UNITED STATES PATENT AND TRADEMARK OFFICE

APPLICATION NO.	FILING DATE	FIRST NAMED INVENTOR	ATTORNEY DOCKET NO.	CONFIRMATION NO.
10/728,191	12/04/2003	Jitendra Mohan	P05747 (NATI15-05747)	7313
23990	7590	11/21/2005	EXAMINER	
DOCKET CLERK P.O. DRAWER 800889 DALLAS, TX 75380			DANG, KHANH	
			ART UNIT	PAPER NUMBER
			2111

Office Action Summary

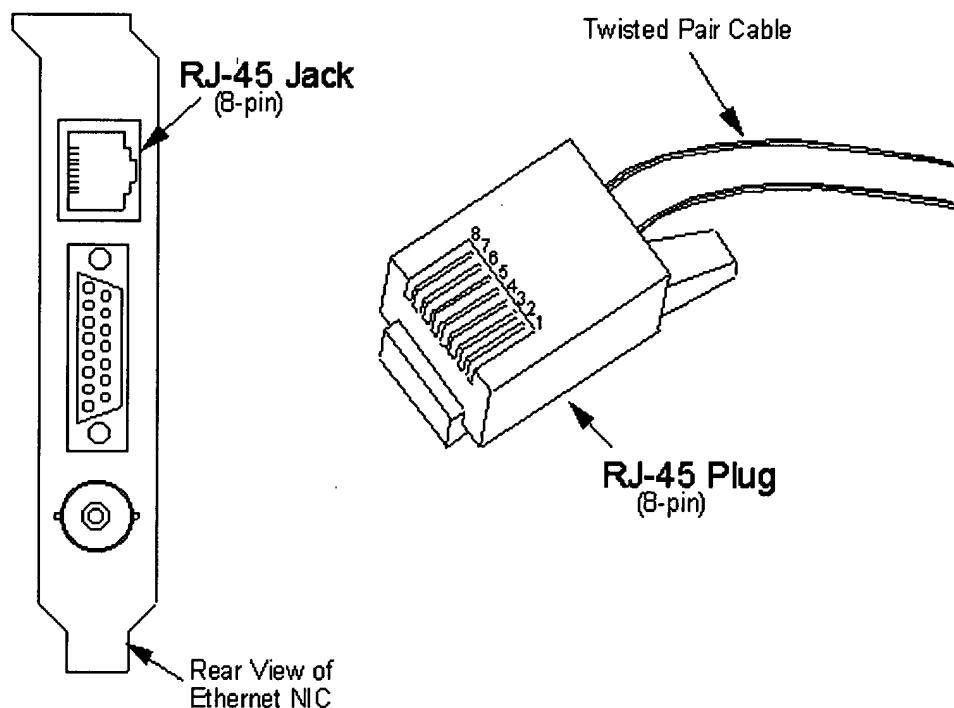
With regard to claim 4, it is clear that the network transmission medium interface is a first network transmission medium interface (one of the interfaces provided by communication port 96/102 for Ethernet network 60, Fig. 3) and wherein a second portion of the docking connector (it is clear that the port replicator connector 100 formed by two portions to form a connection between 90 and 98) is coupled to a second

network transmission medium interface (the other one of the interfaces provided by communication port 96/102 for Ethernet network 60, Fig. 3).
